**ADDENDUM #1  
RESURFACING OF SW DURANT STREET AND SW  
BRIGHTON COURT IN THE TOWN OF FORT WHITE  
L170807TFW**

## SW DURANT ST AND SW BRIGHTON CRT

FINANCIAL PROJECT ID 440005-1-54-01  
NFPS PROJECT ID L170807TFW

REVISIONS				JAMES H. PITMAN P.E. LICENSE NUMBER 42035 NFPS P.O. BOX 3823 LAKE CITY, FLORIDA 32056 CERTIFICATE OF AUTHORIZATION 29011	COLUMBIA COUNTY BOCC			<b>TYPICAL SECTION</b>  SHEET NO.  3
DATE	DESCRIPTION	DATE	DESCRIPTION		ROAD NO.	COUNTY	FINANCIAL PROJECT ID	
					COLUMBIA	440005-1-54-01

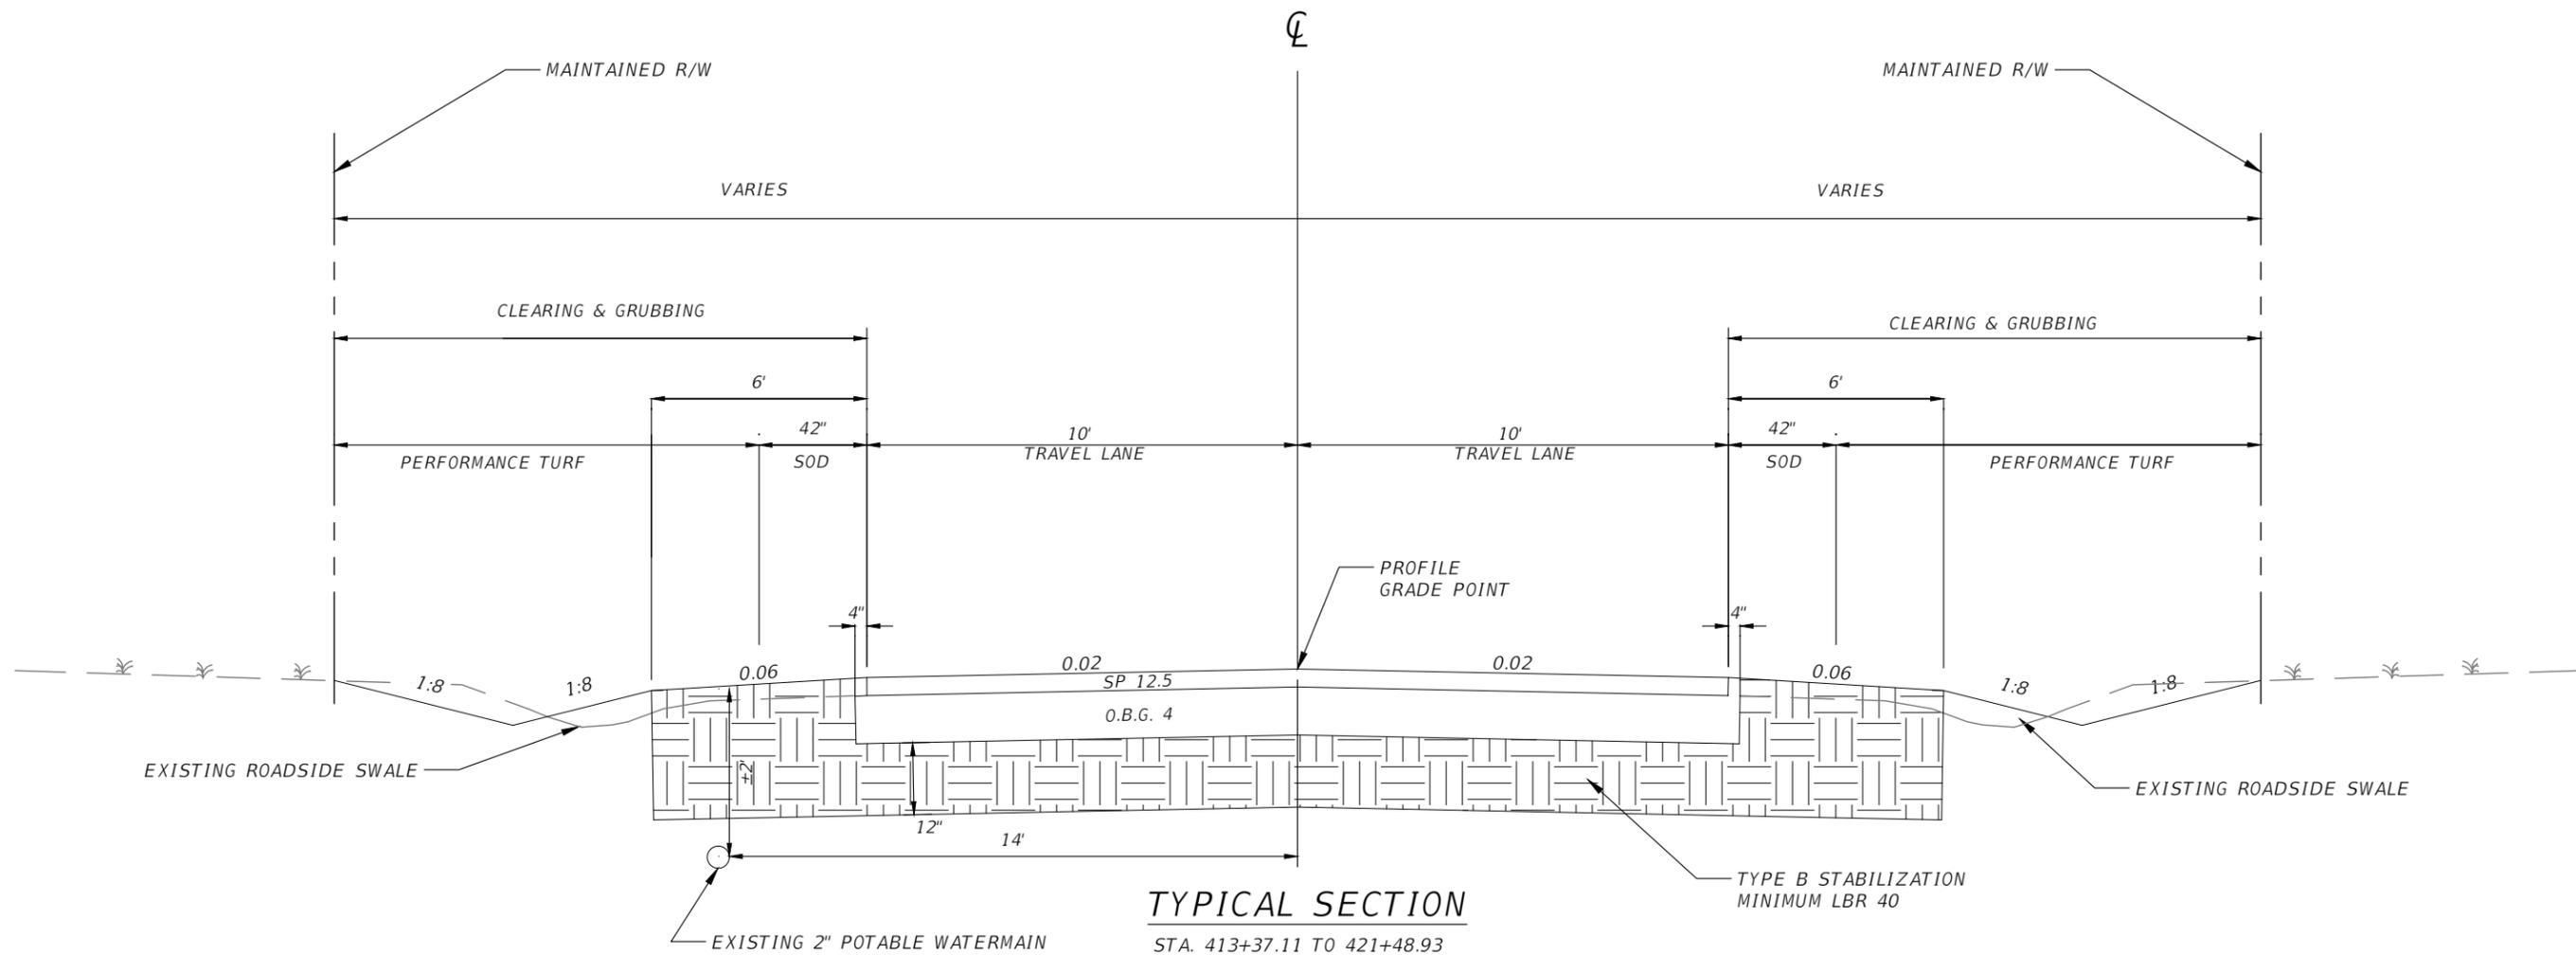
2. The typical section on sheet 3 is for resurfacing. No shoulder work is indicated, the existing shoulder is to remain. However, it also shows a 42" strip of performance turf sod. Are the shoulders to remain undisturbed along the resurfacing streets or will the shoulders be reworked to prepare for a new sod strip?

**Sod should be installed according to Index 105 Treatment 1. Embankment has been increased to account for areas not meeting Treatment 1. See revised bid form.**

2 PRIVATE TURNOUT TO PAVED DRIVEWAYS  
5 SCALE:N.T.S.

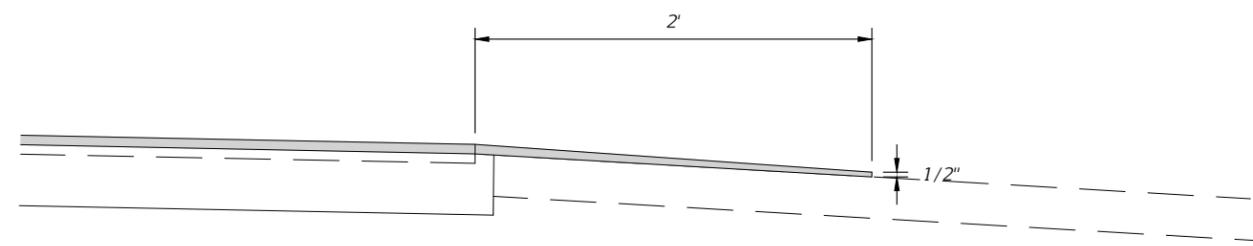
3. Within SW Brighton Court, the existing drives are concrete. Is the resurfacing to stop at the edge of the concrete or will a 2' asphalt apron be installed over the concrete as shown in detail 2/5 on plan sheet 5?

**Construct as shown in detail 2/5 on plan sheet 5.**

**PLAN SHEET**  
**SW BRIGHTON CRT.**

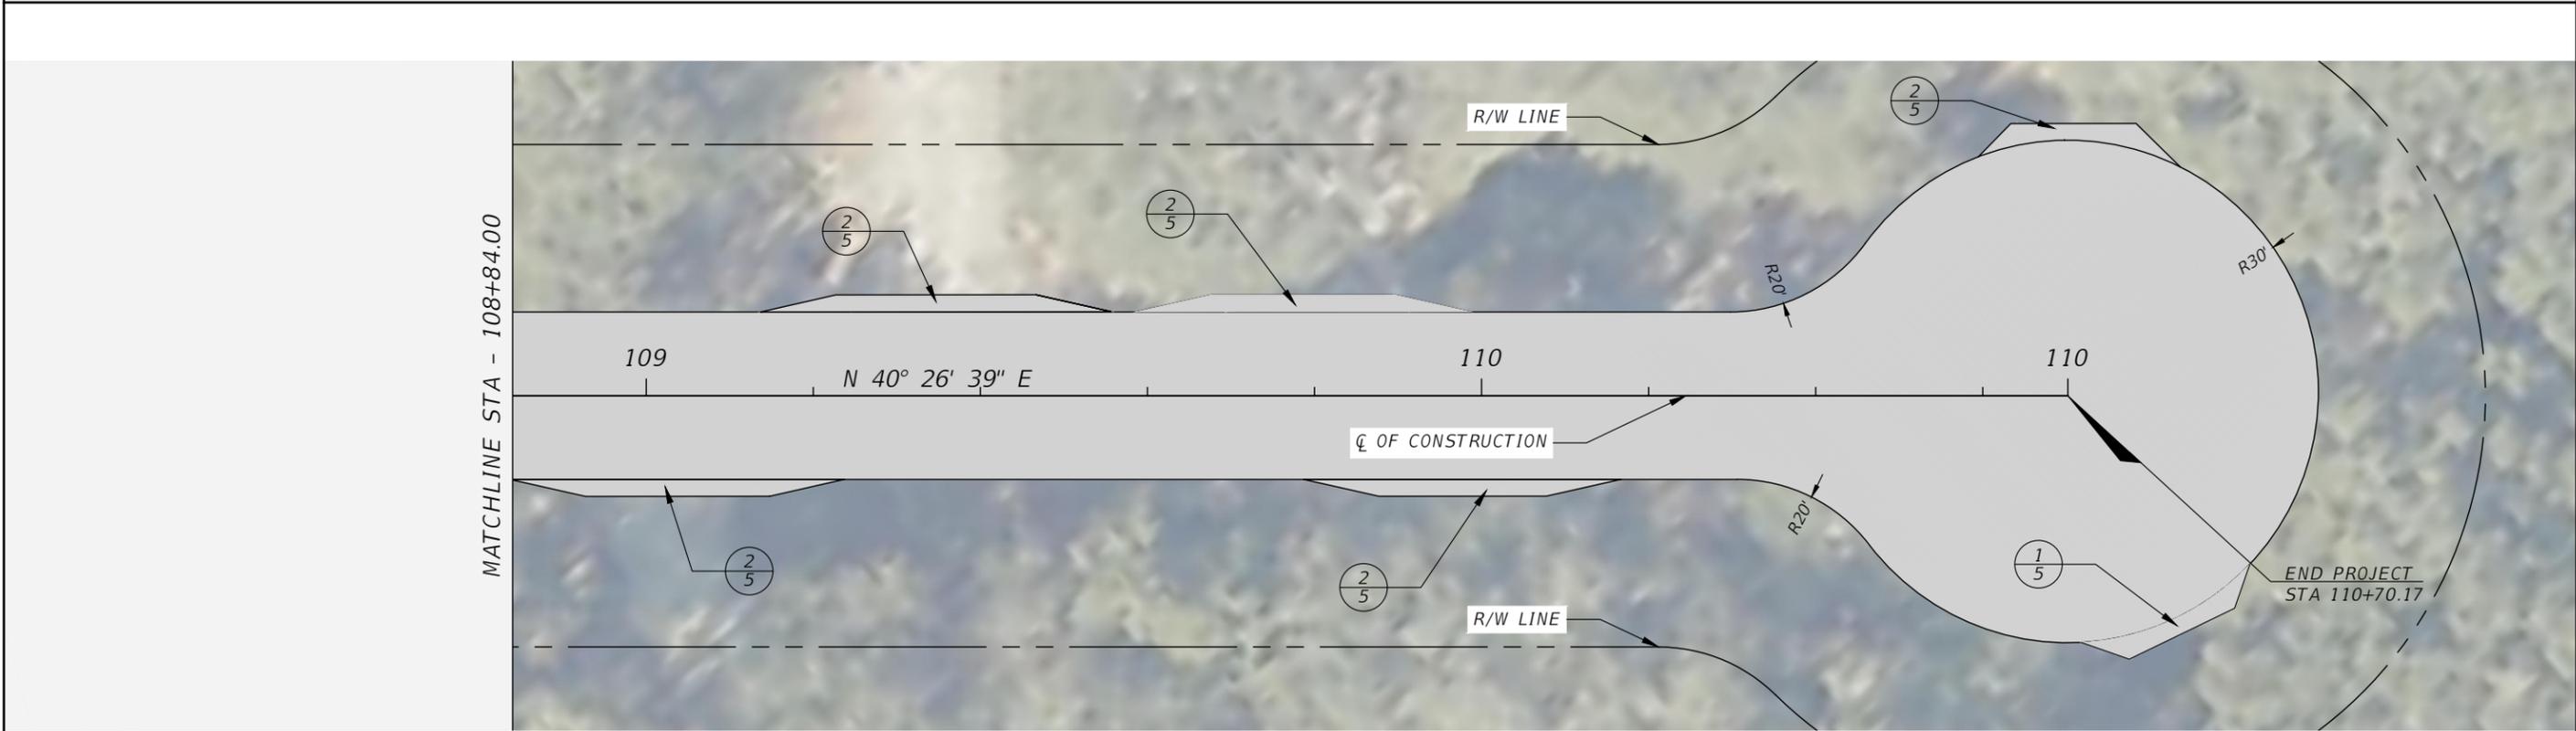
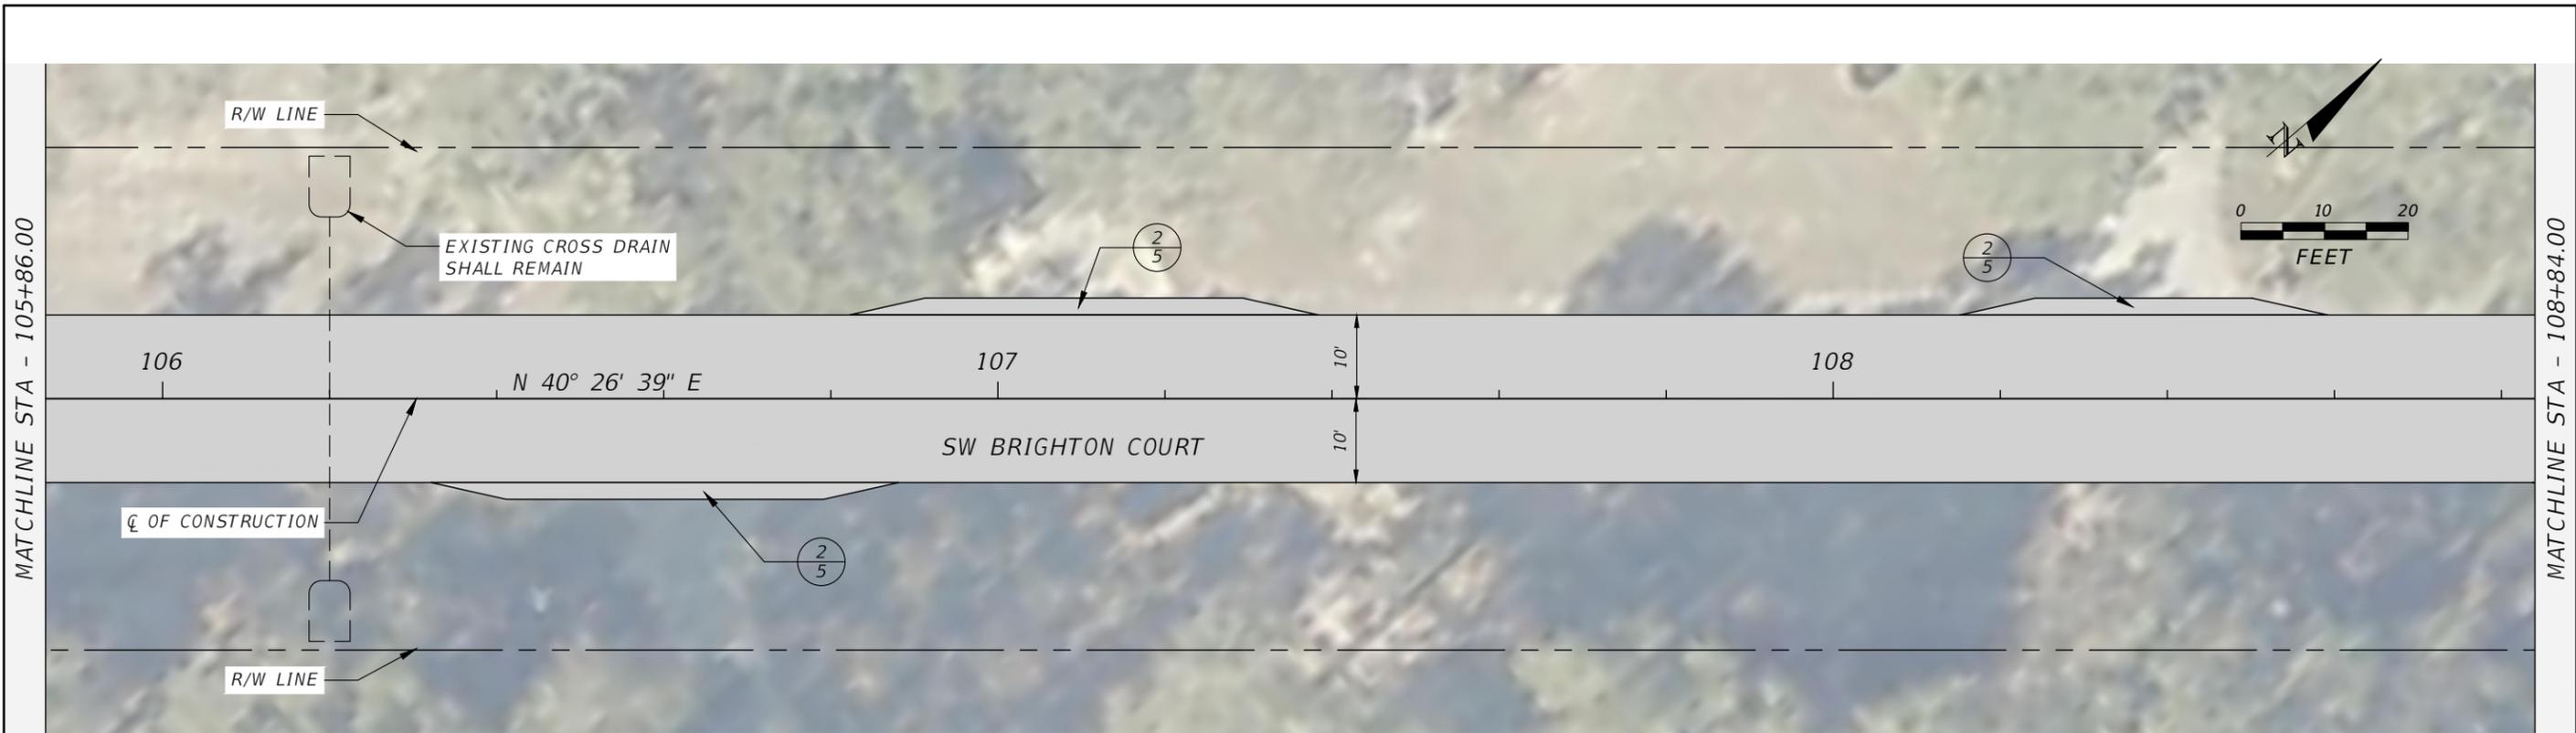
4. There is a bid item for desilting 32 LF of pipe. I did not find the location for the pipe on the plans that need to be desilted. Is the location on SW Walton Glen for the cross drain at station 201+30? The location is needed to identify the pipe size and the amount of buildup.

**There are two cross drains on SW Brighton Court and one on SW Walton Glen. The bid form has been revised to reflect the length of pipe required to be desilted and shown on revised plan sheets 8 & 10.**

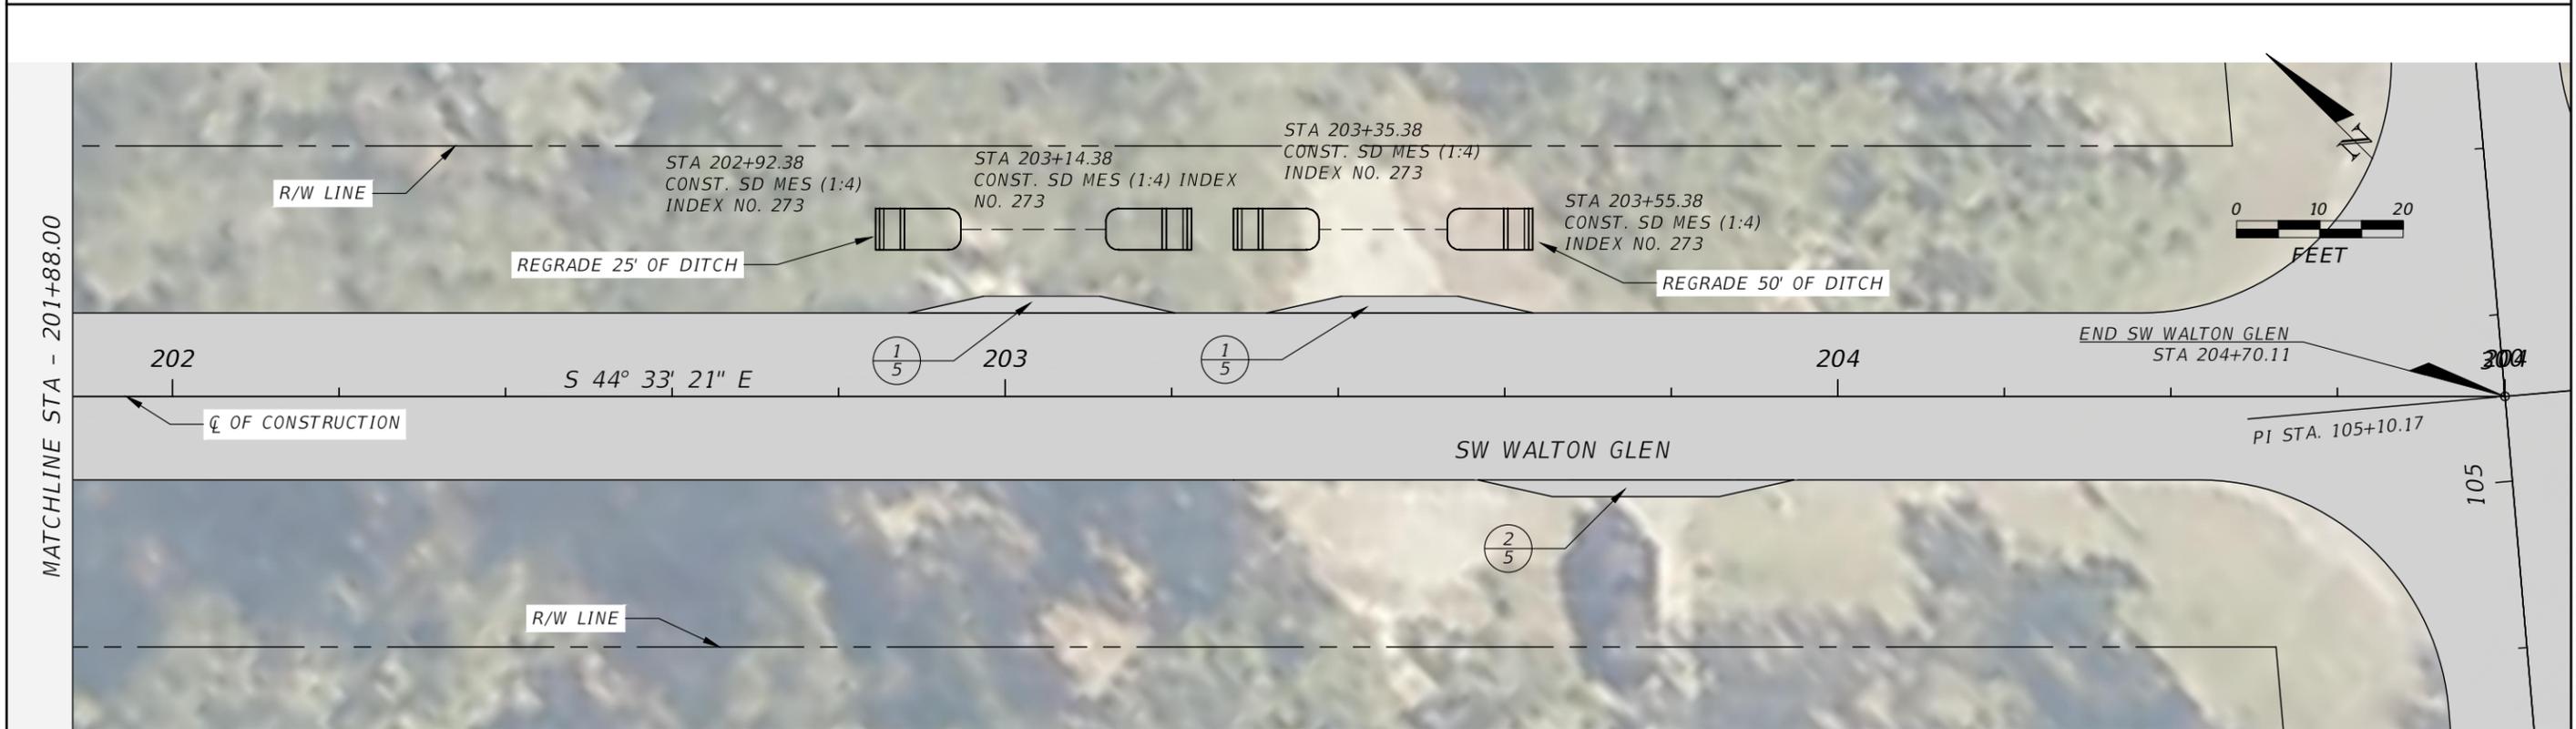
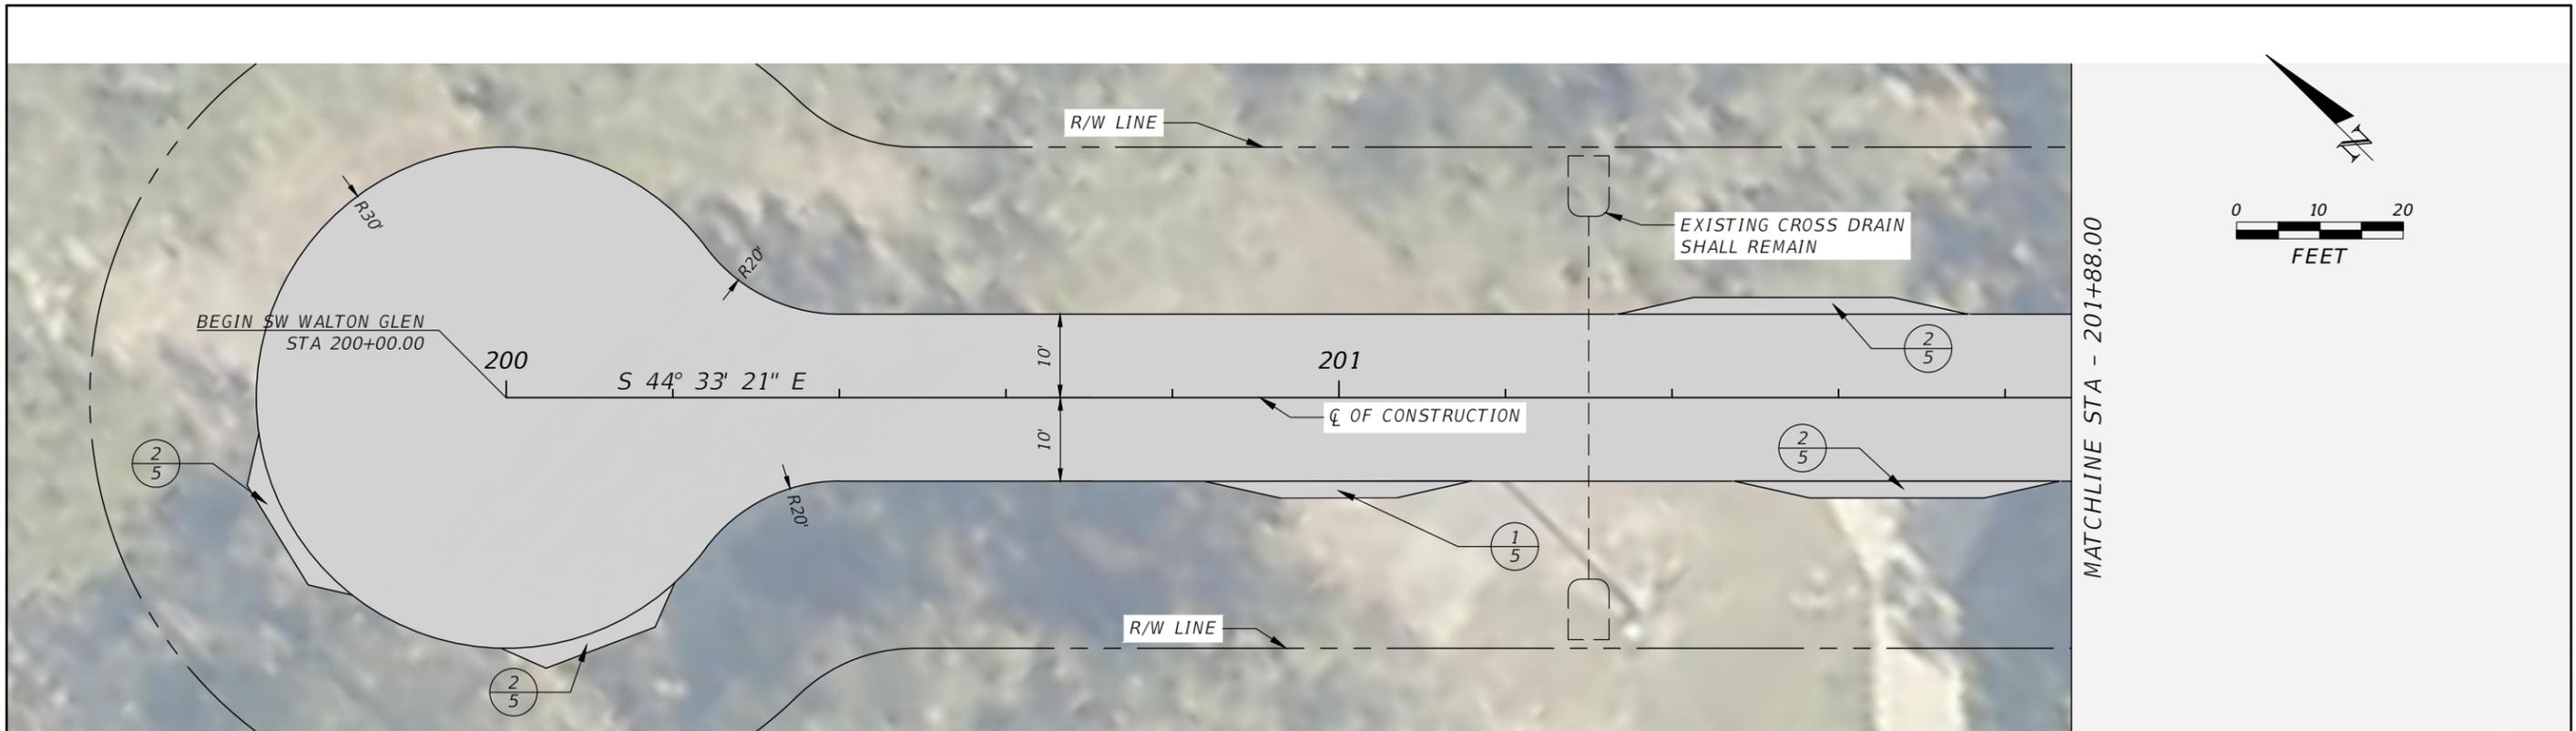
7. The bid schedule shows 4 – 18" MES S/D, where are those pipes located? I only see a C/D at STA 106+20 on SW Brighton Ct? I do see 2 side drains on SW Walton Glen?

**See page 10 of plans for (4) MES.**
